REFERENCE:	Nova Bus Manuals
SECTION:	14 Heating and ventilation
RS N°:	MQR 7621-861
EFFECTIVE IN PROD.:	L654 (2013MA)

SUBJECT:	Recirculation pump hose
JUSTIFICATION:	Heat shield sleeve could be missing and heat deteriorates the hose, leading to a possible coolant leak

N70143 tube and N56614-02
heat resistant sleeve

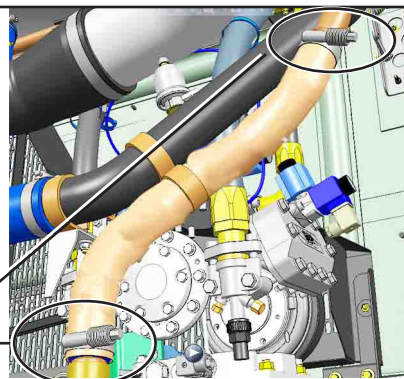
- 1.6. Install the N56614-02 heat-resistant sleeve to the N70143 hose.
- 1.7. Affix the hose and sleeve assembly with the retained P-clamp.

- 1.8. Affix the N70143 hose without the heat resistant sleeve to the pipe with the retained hardware.
- 1.9. Tighten the two clamps to the indicated torque.

Torque to 5.5 ± 0.4 lb-ft
(7.5 ± 0.5 N•m)
